CITY OF GRANT
2026 Roadway Improvements

From: Jennifer Haskamp, AICP
Consulting City Planner

Figure 1. Aerial of Mahtomedi School Campus and location of subject field (outlined in black)

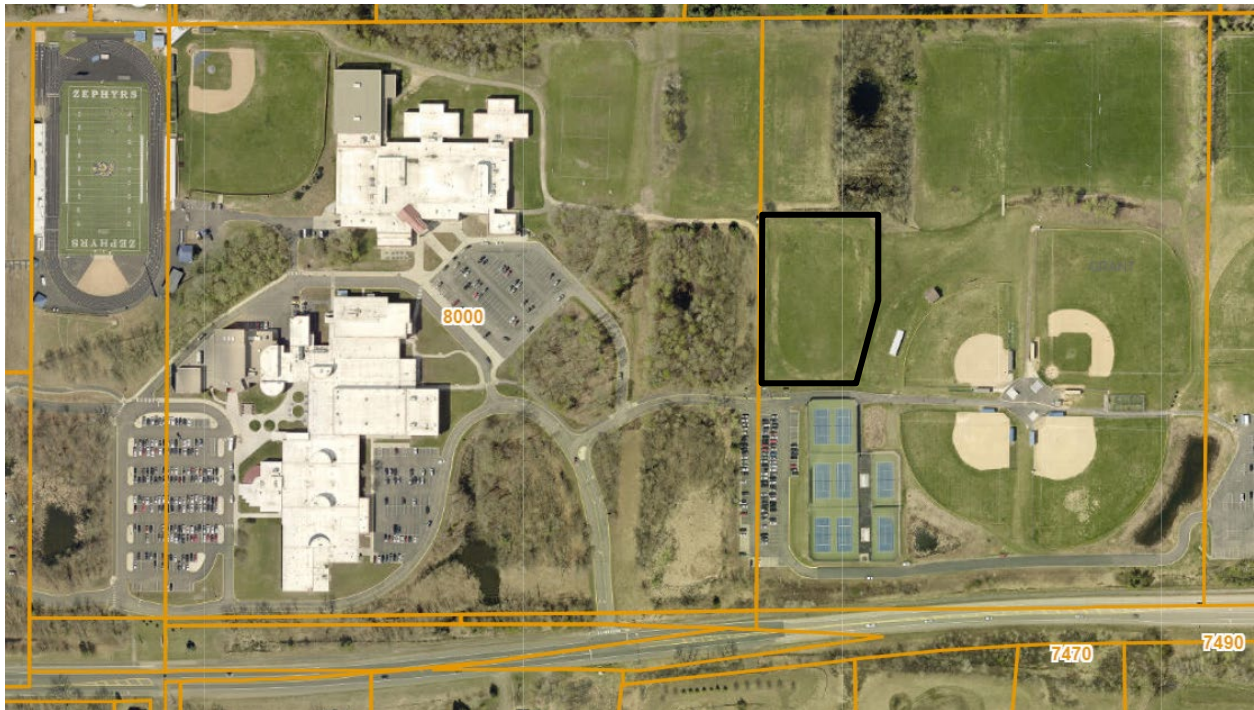
The proposed modifications associated with this CUP Amendment will be made to the existing athletic field generally located north of the tennis courts and northwest of the baseball fields (Figure 1). The field is located within the Mahtomedi School Campus on PID 2803021240002. Per the Applicant's narrative, the proposed modifications are intended to improve field usability, extend seasonal play, and support the community's recreational needs.

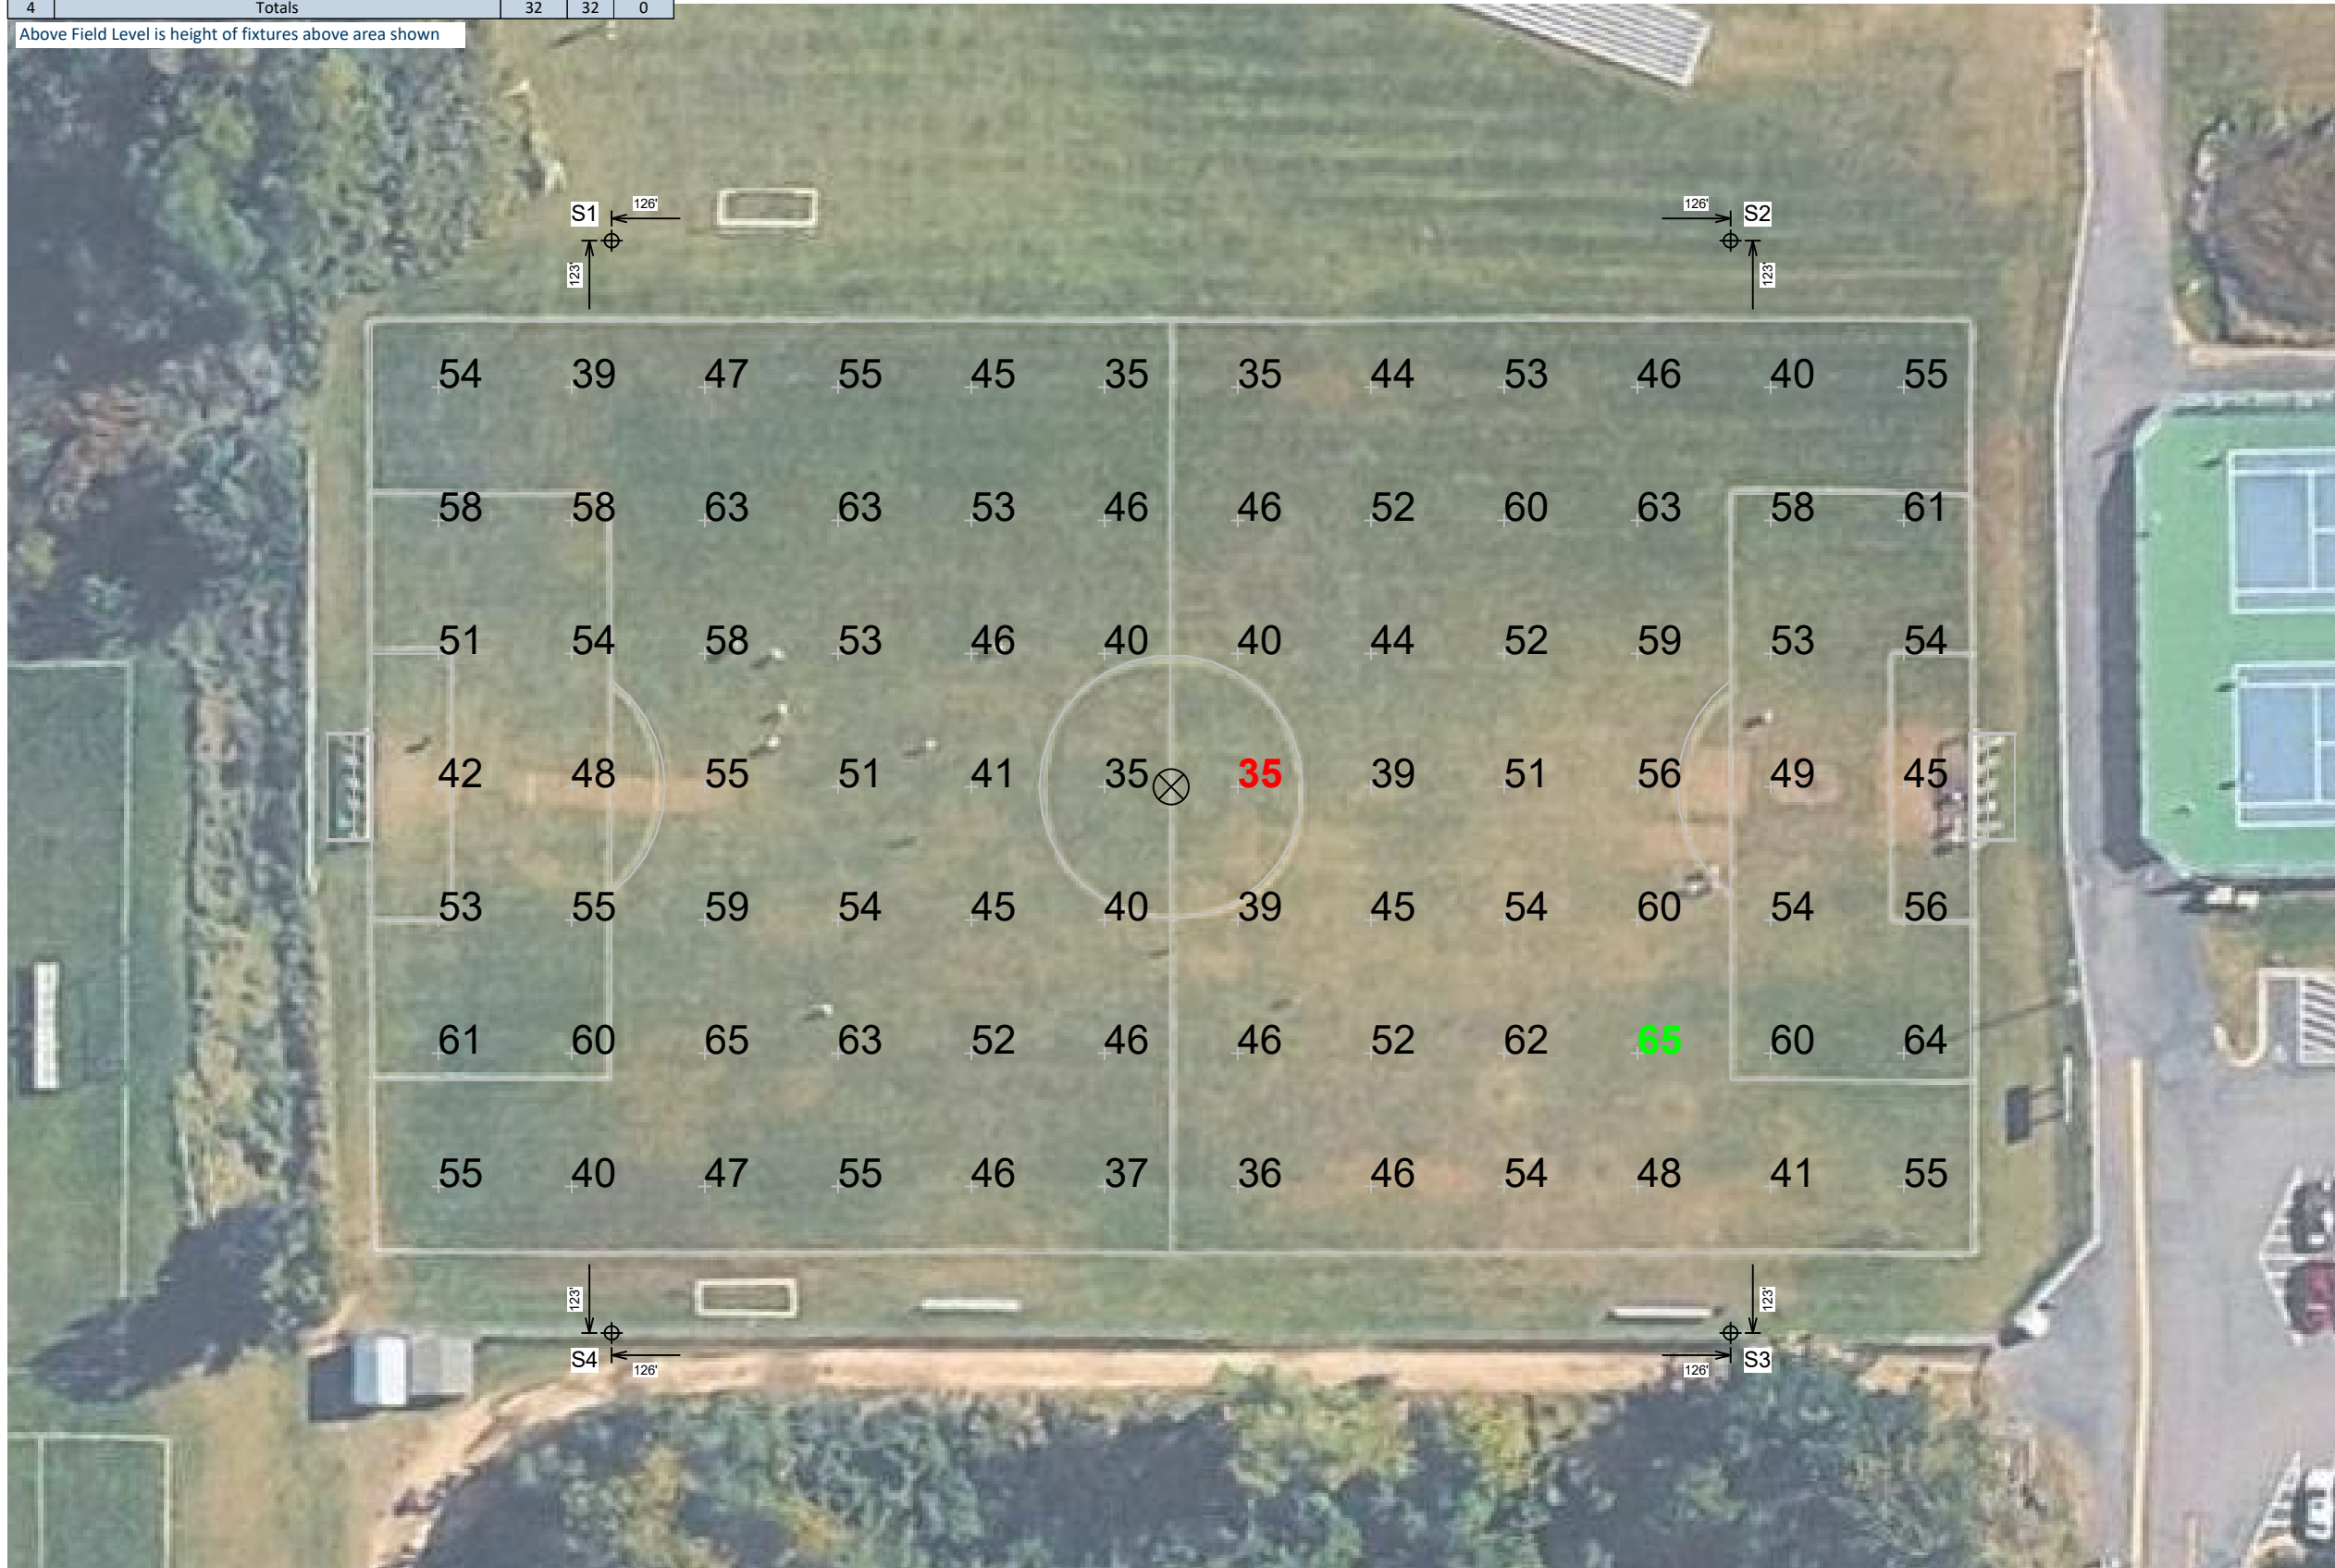
The Applicant's submission includes a light summary that shows general fixture type, fixture heights and location however detailed specifications were not provided. The proposed lighting is assumed to be downcast and directional to light the field surface area and it appears from the photometric plan that the fixtures have a short cutoff area surrounding the perimeter of the field. Some spillage onto driveway and parking area lying south of the field is shown, but these uses are associated with the school campus. While the submitted plans demonstrate that the footcandles at the adjacent property lines will likely be 0, the ambient light and/or visibility of the field light glow from adjacent properties and the right-of-way is possible given the topography, unknown vegetative height and density, and the height of the proposed fixtures.

Additionally, the Applicant's submission does not include the full light detail specification which must be provided to confirm that the type of lighting proposed is consistent with the downcast cut-off shown in a couple of the pictures submitted (see page 13).

within the CUP and therefore it is reasonable to request additional information and evaluation as to why the fixtures cannot be lower than the proposed height. For example, if the fixtures were reduced to 50-feet it is possible that the existing trees and vegetation would provide greater screening of the lights from residence to the north. Given the City's vision to maintain dark skies, reducing the height may better support this objective. Additionally, it is reasonable to establish hours when the lights must be turned off or when such fixtures are not lit to protect the dark sky. If the field is not in use, then the lights should remain off and unilluminated. The Applicant's submission did not include proposed hours for field use and the narrative simply indicated that the purpose of the field lighting is to extend the hours of use for the field. Staff recommends discussion by the City Council regarding 1) the height of fixture and whether exploration of a shorter fixture height is warranted; and 2) the hours of operation for the field lighting, which may be 10 PM as currently regulated within the permit for other lighting, or at another time deemed appropriate by the Council.

Staff recommends including a condition that the lighting must be downcast to reduce ambient lighting and light fixture details must be provided. A clearly labeled photometric plan indicating the footcandles and at adjacent north and south property lines should be submitted and included as an attachment to this permit. Staff further recommends including a condition that the lights must remain off unless the field is actively in use. After the Council discussion and public testimony, hours of operation for the field lighting should be identified within the updated conditions. Finally, the City Council should discuss and determine if the Applicant should evaluate lowering the height of the fixture, and if so, include such requirement as a condition within the amended permit or table the item until more information is provided.
